SUBJECT: AMENDMENT 8 TO SOURCE MATERIAL LICENSE SUA-1358, WHITE MESA
URANIUM MILL - MODIFICATIONS TO TAILINGS IMPOUNDMENT LEAK
DETECTION MONITORING PROGRAM

TECHNICAL EVALUATION REPORT

FACILITY: White Mesa Uranium Mill

Figure 1. Flowchart of Final Revised Tailings Impoundment Leak Detection Monitoring Program

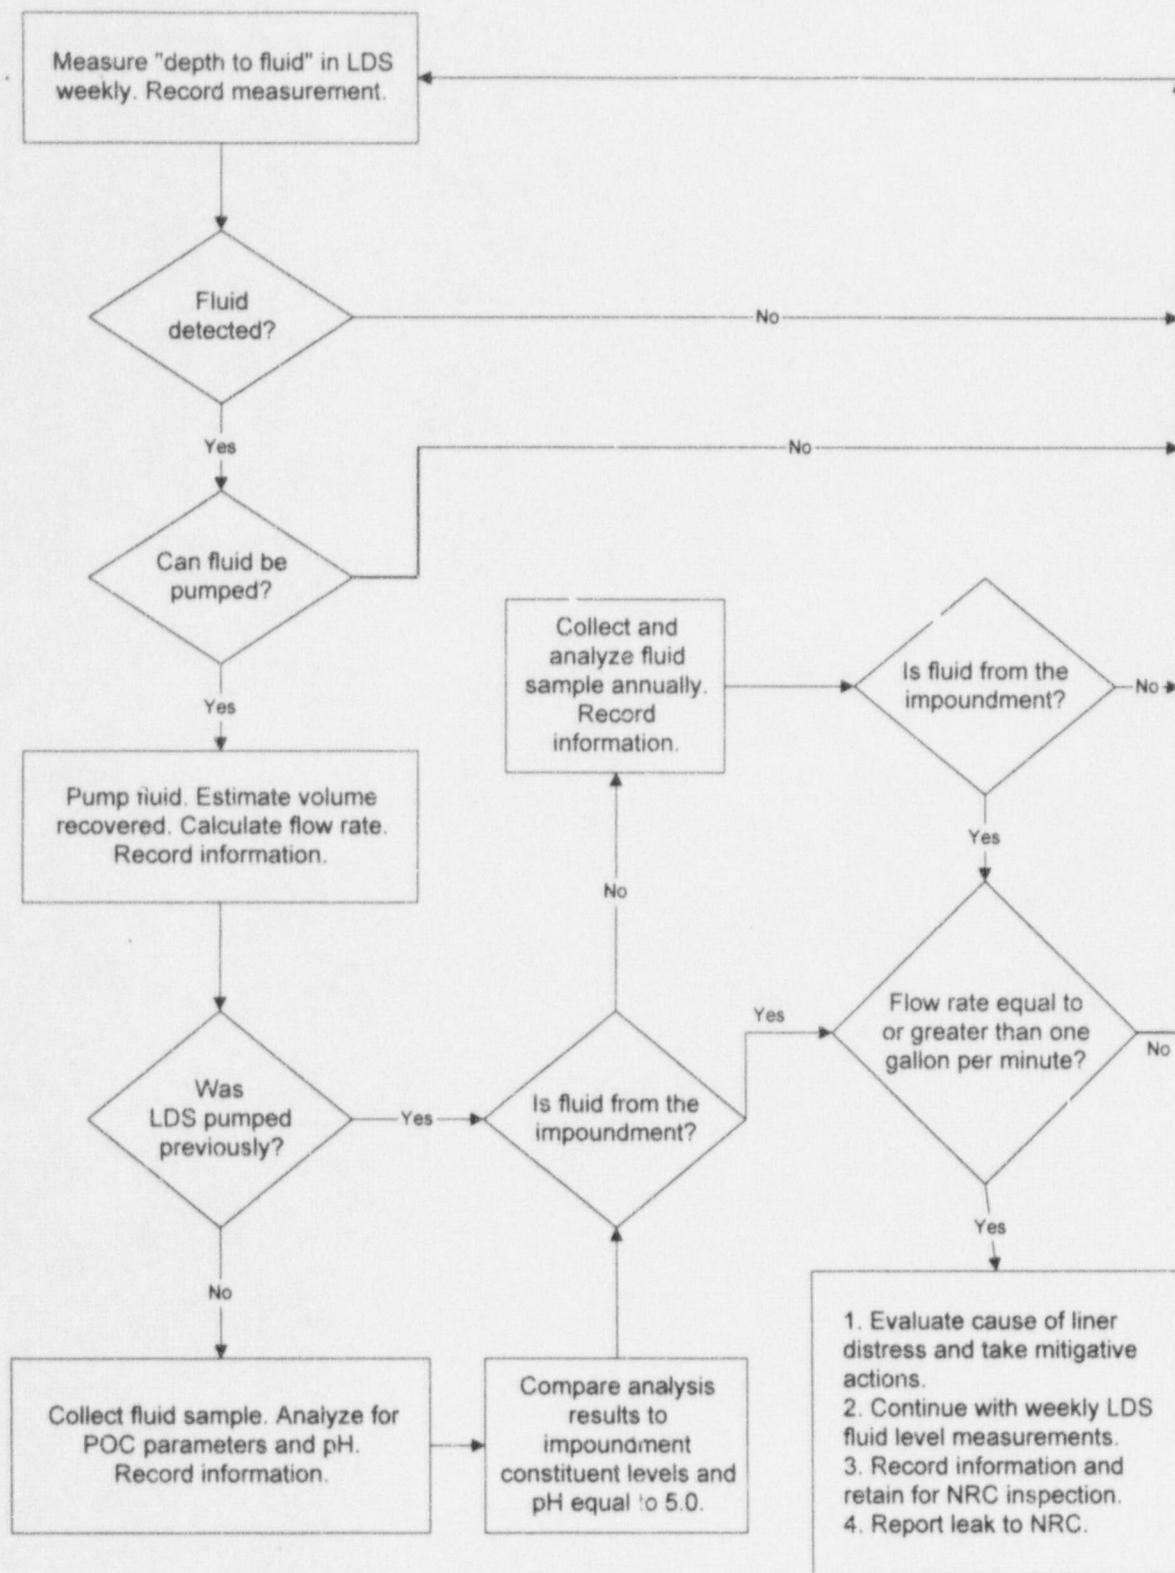
In general, the staff finds IUC's proposed approach acceptable. The staff recognizes that monitoring of the liner leak detection system serves as an early warning of potential liner failure and does not constitute a monitoring program for initiating ground-water corrective action. The staff also agrees that the primary method of confirming liner distress or failure should be the determination of a flow rate through the liner after the origin of the fluid in the leak detection system is determined. The licensee's proposed monitoring program was evaluated by constructing a decision flow chart (Figure 1), based on information supplied by the licensee.

The licensee's approach appears to address current site conditions and potential future events. However, the staff recommended minor modifications to the licensee's proposal to address reporting requirements of 10 CFR 40.60(b), and additional measures to mitigate the potential impact from a confirmed liner failure. These included: (1) specifying the time frames for reporting leaks from an impoundment to NRC (the initial telephone report within 48 hours and a written report within 30 days); and (2) retaining the analysis results and flow-rate calculations on-site for NRC inspection. Figure 1 includes these recommended changes.

IUC agreed to these modifications by telephone on July 16 and September 2, 1998.
